HISTORIC AND DESIGN REVIEW COMMISSION

June 19, 2019

HDRC CASE NO:	2019-247
ADDRESS:	909 N HACKBERRY ST
LEGAL DESCRIPTION:	NCB 529 BLK 2 LOT N 92.5 FT OF 13 & 14
ZONING:	IDZ, H
CITY COUNCIL DIST.:	2
DISTRICT:	Dignowity Hill Historic District
APPLICANT:	Haley Serna/Open Studio Architecture
OWNER:	Michael & Teresa Garansuay
TYPE OF WORK:	Construction of 2, two-story, residential structures, and two rear residential structures
APPLICATION RECEIVED:	April 30, 2019
60-DAY REVIEW:	June 28, 2019
CASE MANAGER:	Edward Hall
REQUEST:

SITE PLAN

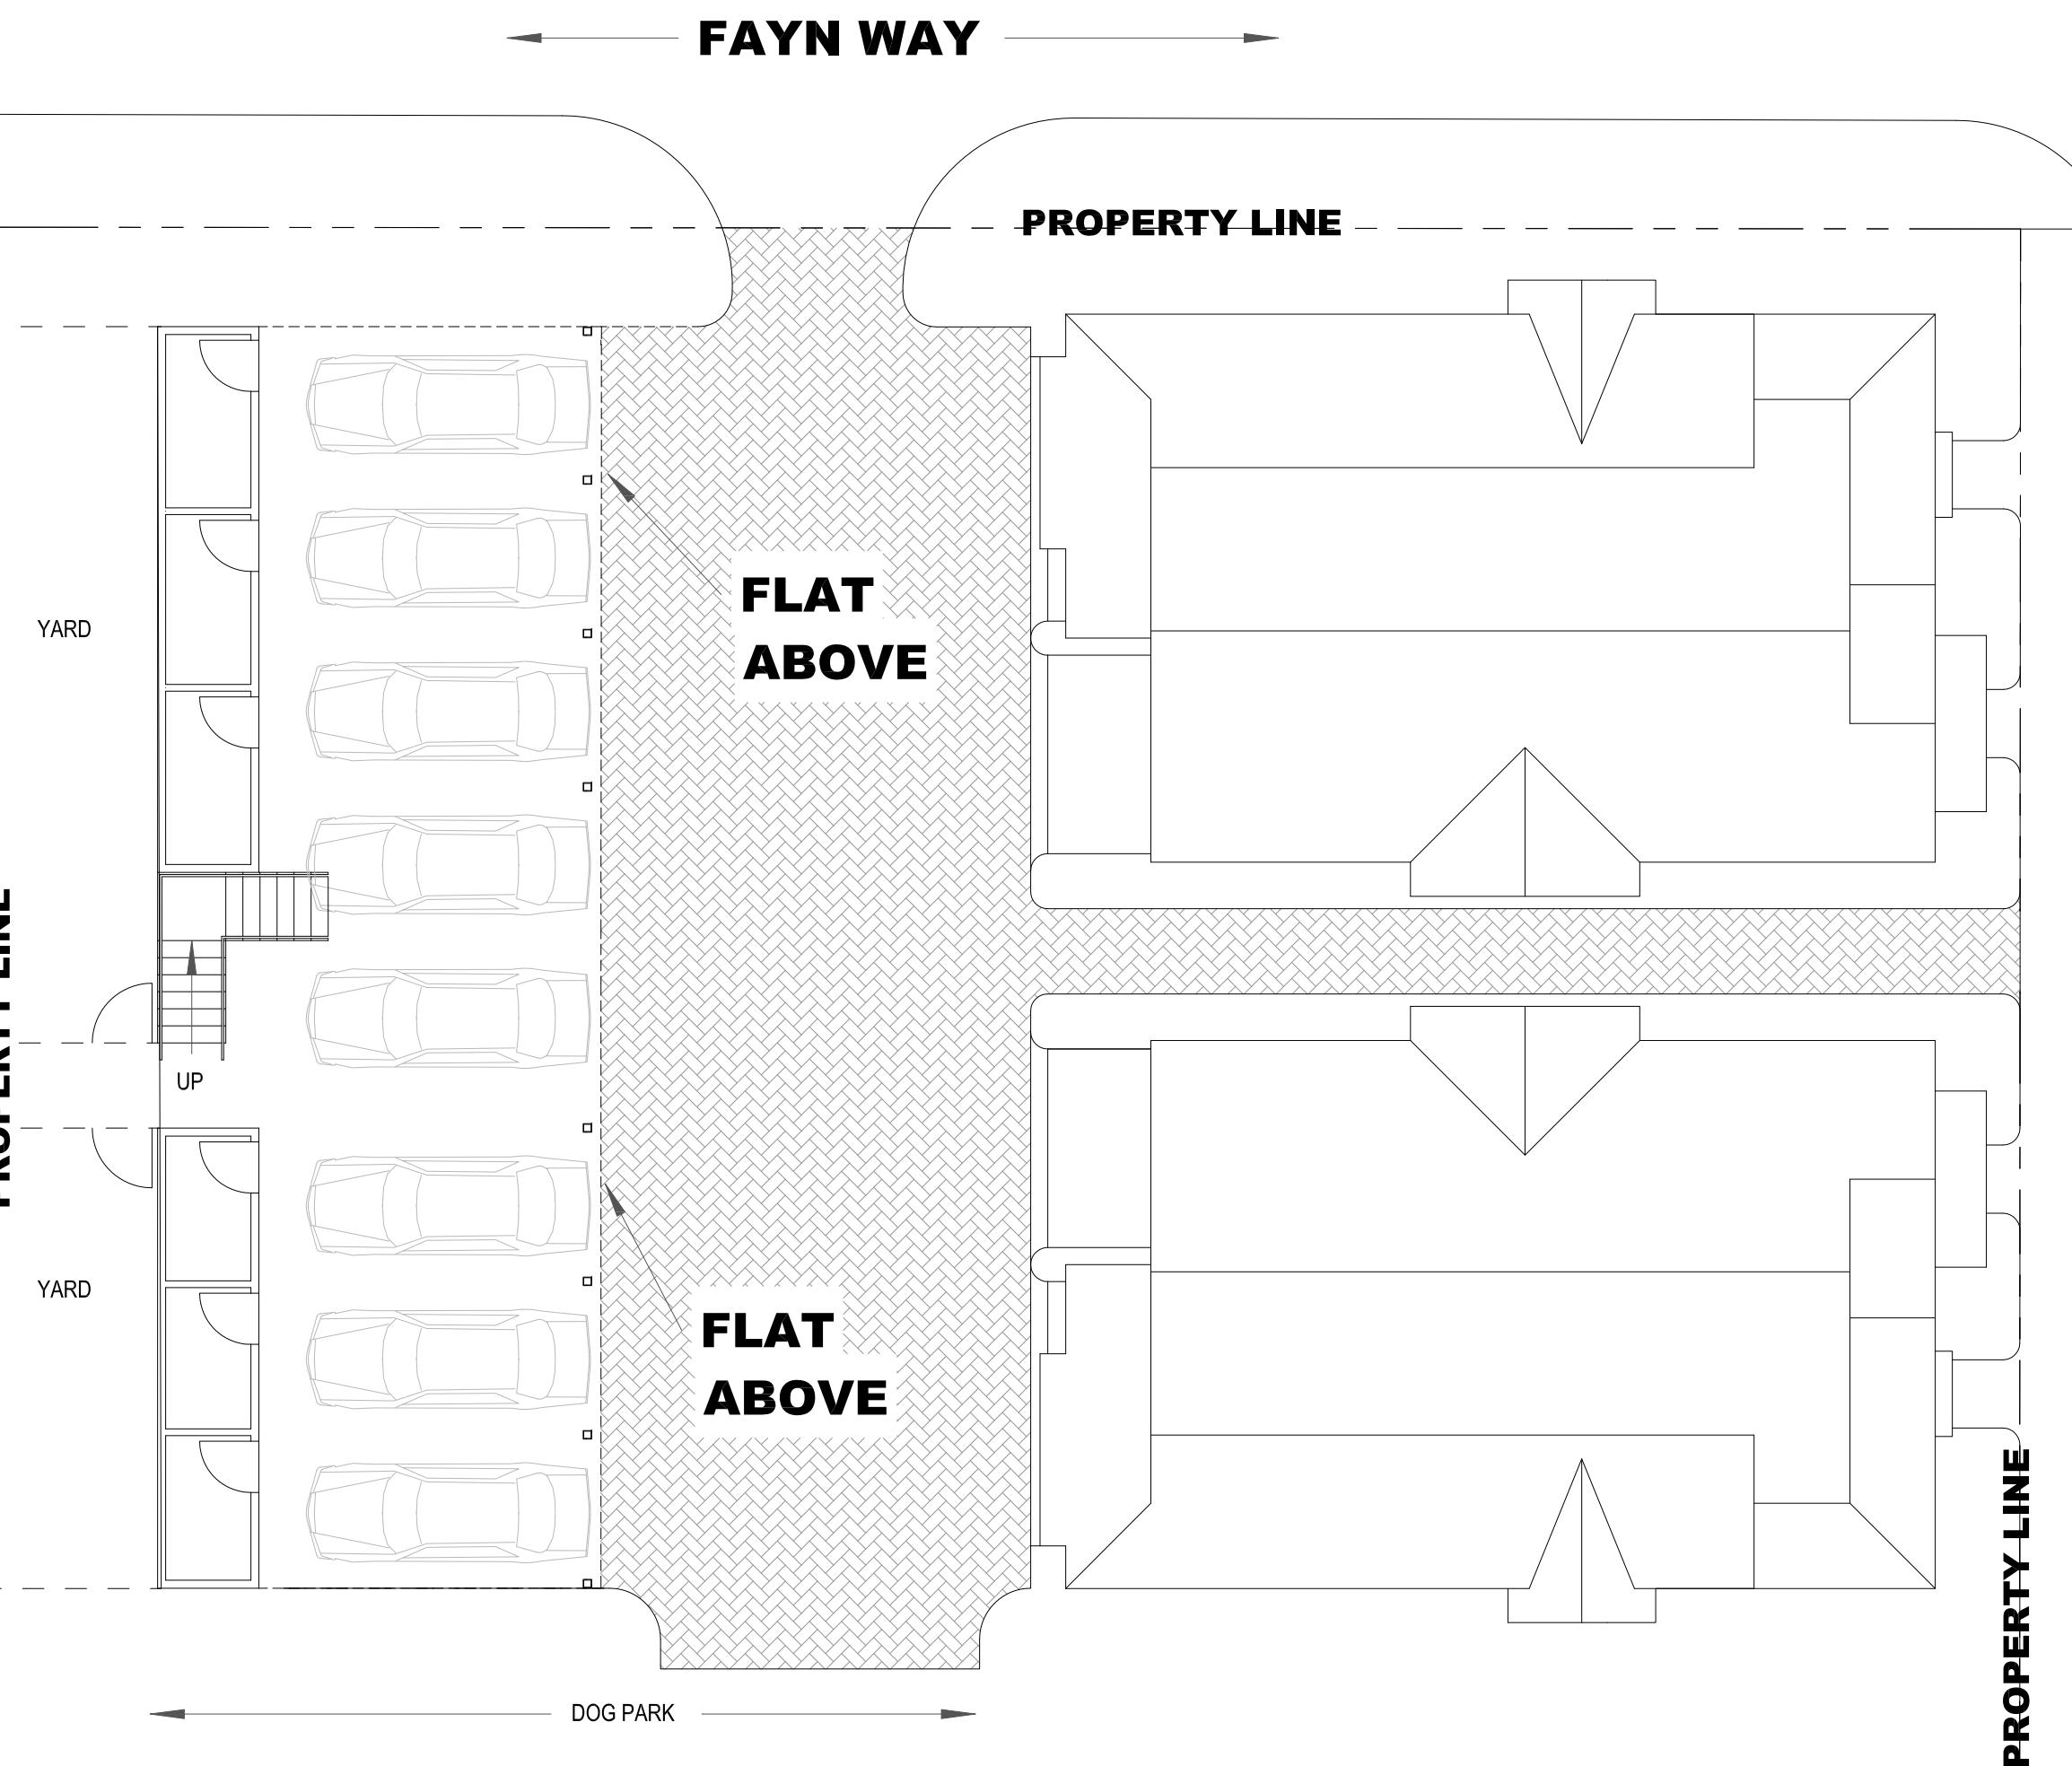
- e. LOT COVERAGE – Per the Guidelines, the building footprint for new construction should be no more than fifty (50) percent of the size of the total lot area. The applicant has proposed footprints for four structures which is atypical of the historic development pattern within the district. The applicant is responsible for complying with the Guidelines and ensuring that the proposed lot coverage does not exceed fifty (50) percent.

- f. VEHICULAR ACCESS – The applicant has proposed vehicular access into the site from Fayn Way. The Guidelines for Site Elements 5.B.i. notes that a similar driveway configuration to those that are found historically within the district should be used for new driveways. Typically, driveways are ten (10) feet wide within the Dignowity Hill Historic District. The applicant has proposed an initial curb cut and driveway with that is comparable to those found historically within the district.

- g. SITE PAVING – The applicant has proposed an amount of site paving that per the submitted site plan, appears inconsistent with the amount of site paving that is found historically within the Dignowity Hill Historic District. The applicant has proposed pervious paving on site.

- 1c. **SETBACKS (Fayn Way)** – The applicant has not noted a side setback on Fayn Way. On this block, Fayn Way connects N Hackberry to N Mesquite. There are no primary historic structures that feature a front orientation toward Fayn Way. On other block, such as across N Hackberry at N Hackberry and Fayn Way, historic structures feature a minimal side setback from the Fayn Way, approximately ten (10) feet.

- 1e. **BUILDING SPACING** – The applicant has proposed spacing between the two primary structures that approximately eight (8) feet; less than that which is found historically within the Dignowity Hill Historic District. Staff finds that additional building should be incorporated into the design.

- i. That the applicant ensure that lot coverage does not exceed more than fifty (50) percent as noted in finding d.
- ii. That the applicant install a driveway and site paving that are consistent with the Guidelines and the historic examples found throughout the Dignowity Hill Historic District as noted in findings e and f.

- iii. That all mechanical equipment be screened from view from the public right of way as noted in finding g.
- iv. That the applicant submit a site plan or a setback diagram which notes the proposed setback is appropriate and consistent with the Guidelines as noted in finding 1b and 1c.

- v. That the applicant either reduce the proposed massing. As proposed, the massing is not appropriate for this lot.
- vi. That the applicant provide a large separation between structures as noted in finding 1e.

ELEVATION STUDY

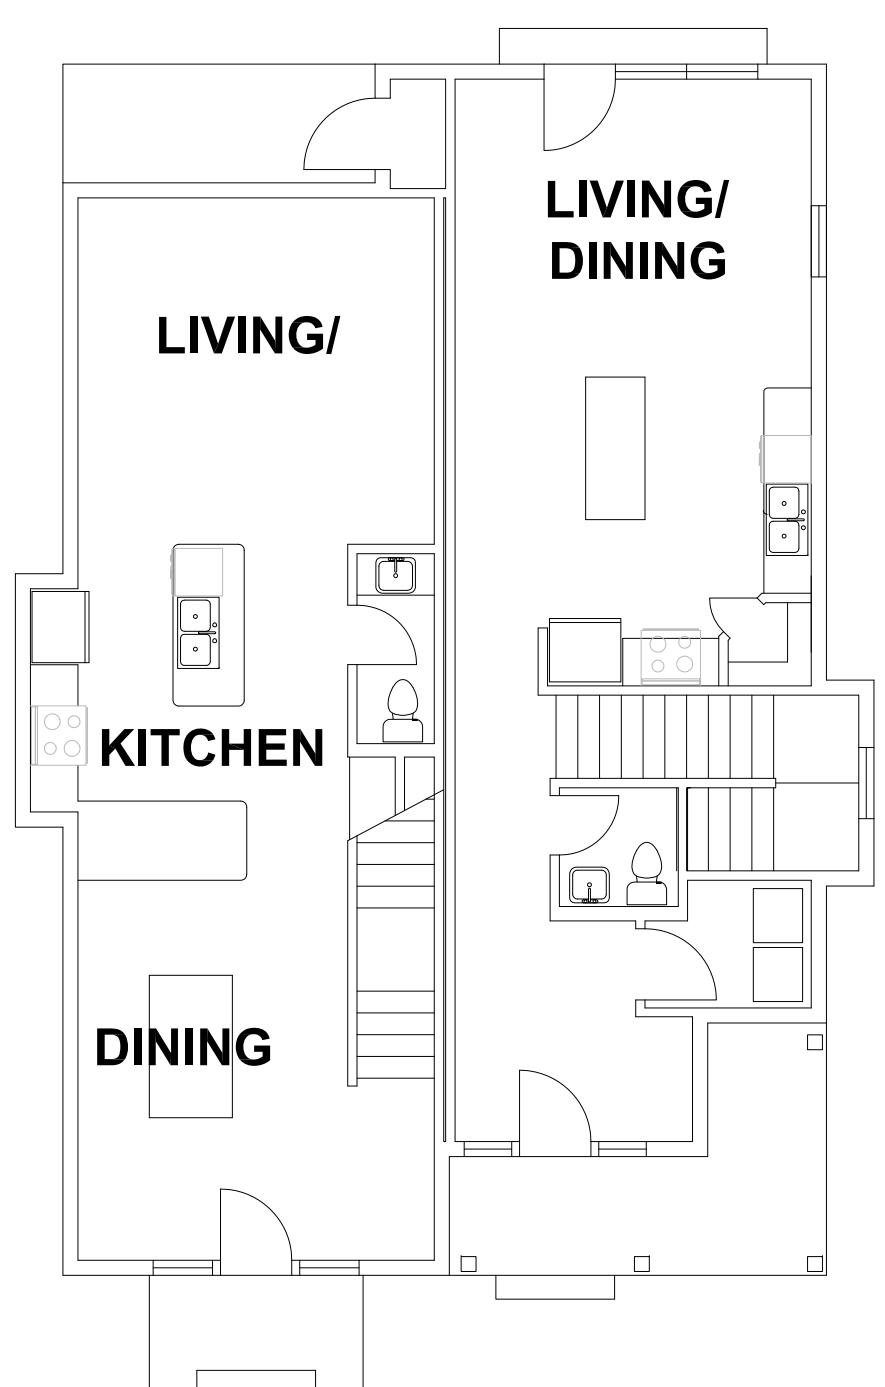
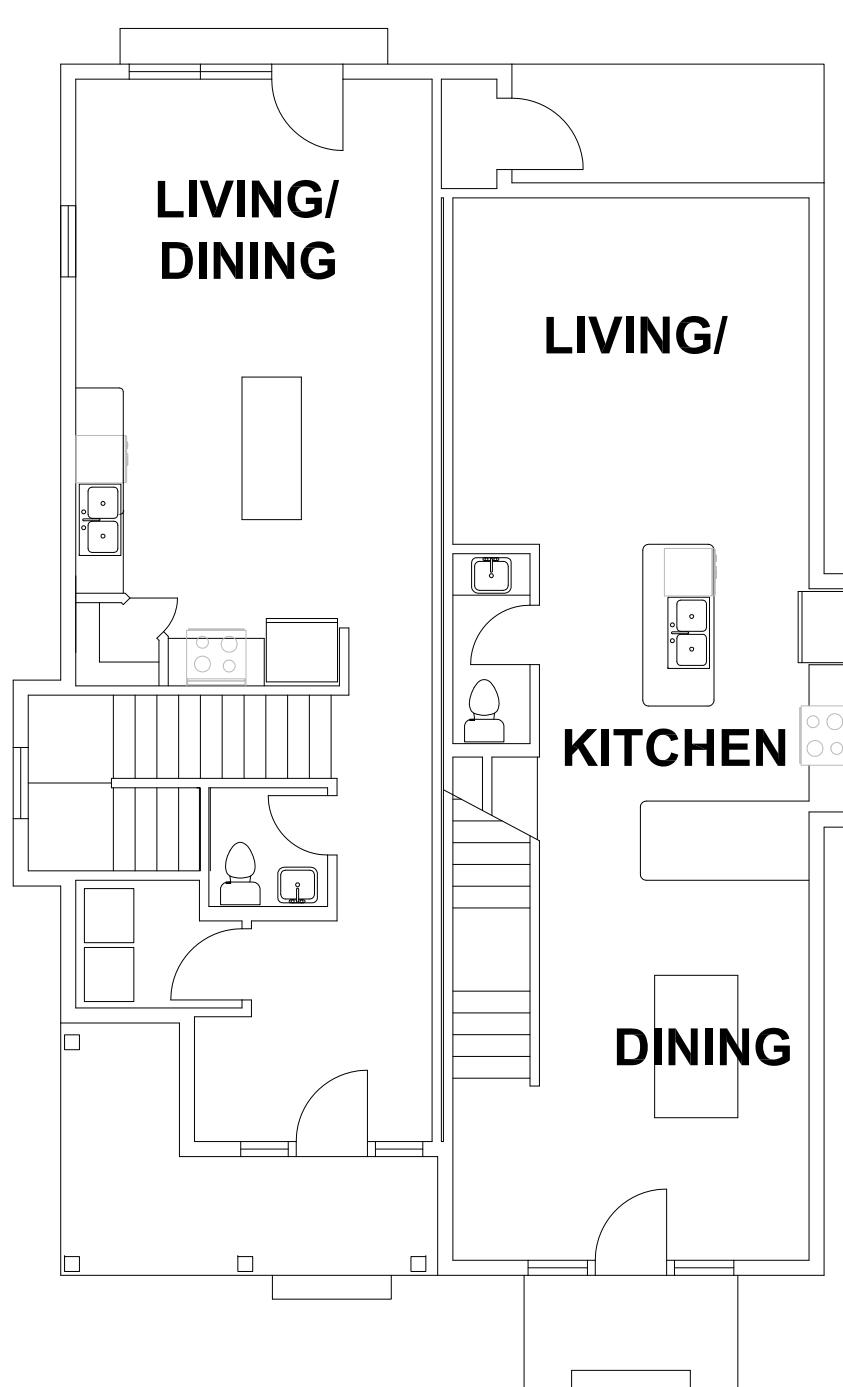
- 1d. **SCALE & MASS** – Per the Guidelines for New Construction 2.A.i., a height and massing similar to historic structures in the vicinity of the proposed new construction should be used. In residential districts, the height and scale of new construction should not exceed that of the majority of historic buildings by more than one-story. This block on N Hackberry features single story structures. There is an example of a two-story, historic structure in the immediate vicinity, which is located at the corner of N Hackberry and Hays. The applicant has modified the proposed massing and architectural elements of the proposed structures to generally feature elements that are found historically within the district. While staff finds that two structures of this size are inconsistent with the Guidelines and historic development pattern, as standalone structures, the massing is generally appropriate.

- 1f. **FOUNDATION & FLOOR HEIGHT** – According to the Guidelines for New Construction 2.A.iii., foundation and floor height should be aligned within one (1) foot of neighboring structure's foundation and floor heights. Per the elevations submitted with the application documents, the applicant has proposed a foundation height of at least one (1) foot. Staff finds the proposed foundation heights to be appropriate; however, the applicant should confirm the exact height.

- 1h. **WINDOW & DOOR OPENINGS** – The applicant has proposed window and door openings that are generally sized consistently with those found historically within the Dignowity Hill Historic District. Staff finds that all grouped windows should be separated by a mullion of at least six (6) inches in width. Additionally, staff finds that additional fenestration should be added on portions of the façade that are blank, primarily kitchen and dining rooms on the first floor.

- vii. That the applicant confirm that a foundation height that is consistent with the Guidelines is utilized as noted in finding 1f.
- viii. That all grouped windows be separated by a mullion of at least six (6) inches in width. Additionally, additional fenestration should be added on portions of the façade that are blank, primarily kitchen and dining rooms on the first floor, as noted in finding 1h.
